## WINSOME: PRELIMINARY PLAN AMENDMENT

### LETTER OF INTENT

JUNE 2021

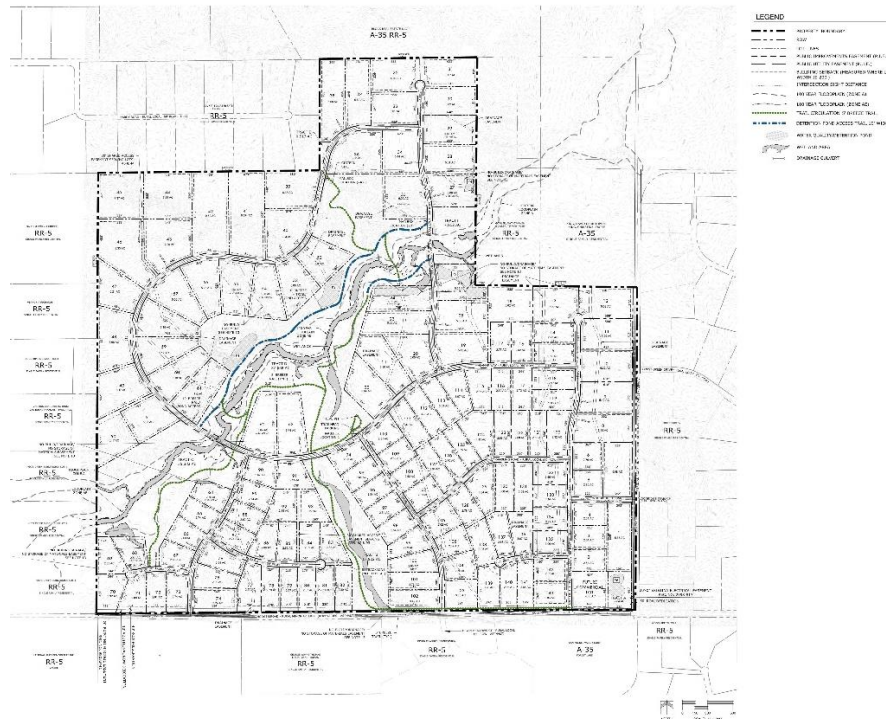
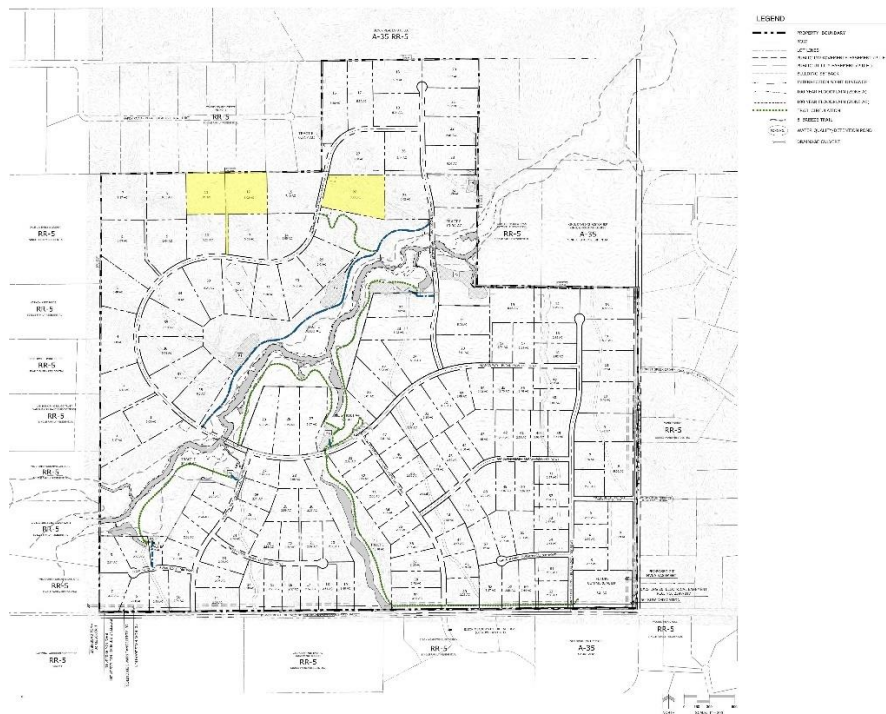
RR-5

Please provide an  
explanation of these  
changes as well.
